PLANNING DIVISION REPORT DEPARTMENT OF PLANNING AND COMMUNITY AND ECONOMIC DEVELOPMENT Of May 2, 2007

RE: I.D. #06313, Demolition Permit and Conditional Use - 5320 Lake Mendota Drive

5320 Lake Mendota Drive Conditional Use and Demolition

5320 Lake Mendota Drive. Proposed demolition for new house. Small house built, according to the assessor, in 1918, probably as a cottage, with later alterations.

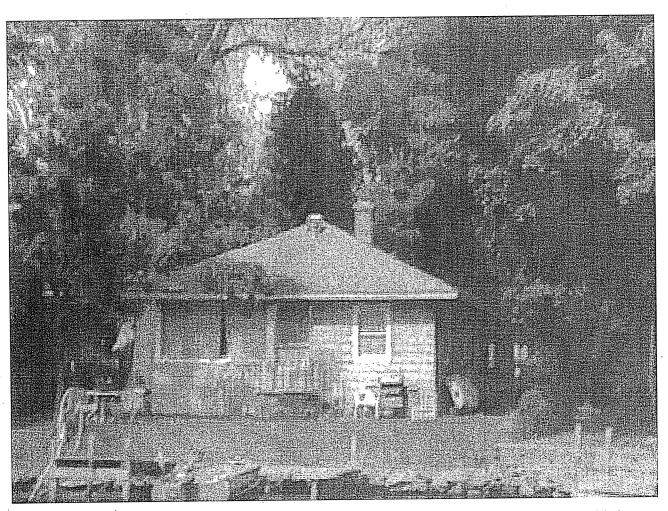
The Planning Division has not inspected the inside of the residence to be demolished but believes the house to be in below average condition based on photos of the interior and exterior provided by the applicant. The photos appear to show evidence of structural disrepair, including a sagging roof, uneven settling of the structure and damaged and worn interior surfaces. The applicant asserts that the existing structure is unsuitable to be added onto and that the cost to repair the structure exceeds its value. Staff is not opposed to the demolition of this residence and
